6300000 CONDUIT  
COMMENTS FROM INTERNAL/INDUSTRY REVIEW

FIGURE 4.04A

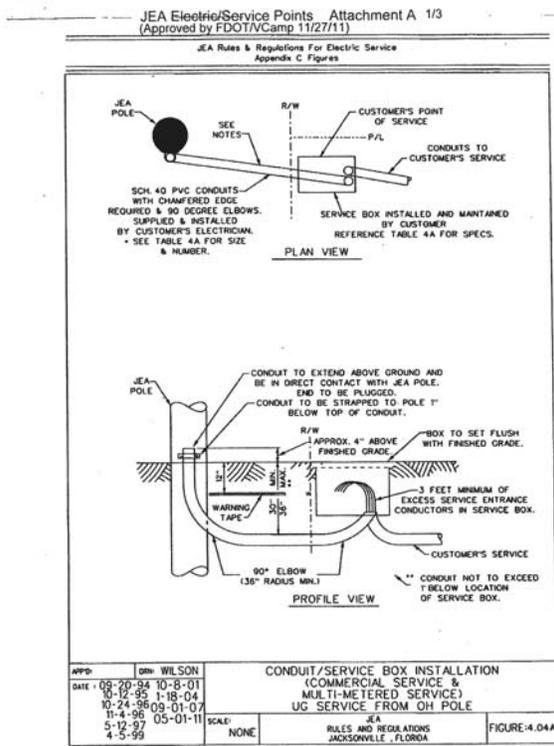
630-3.1 does mention complying with NEC or NESC however, the fourth paragraph still dictates SCH 80 PVC or fiberglass conduit for exposed installations (we need SCH 40).

Response: We agree that the construction and materials used up to the customer's point of service must meet NESC requirements, but can be at the discretion of the utility provider. We have no objection to JEA's current practice and believe that a change to the document is not required at this time.  
No changes made.
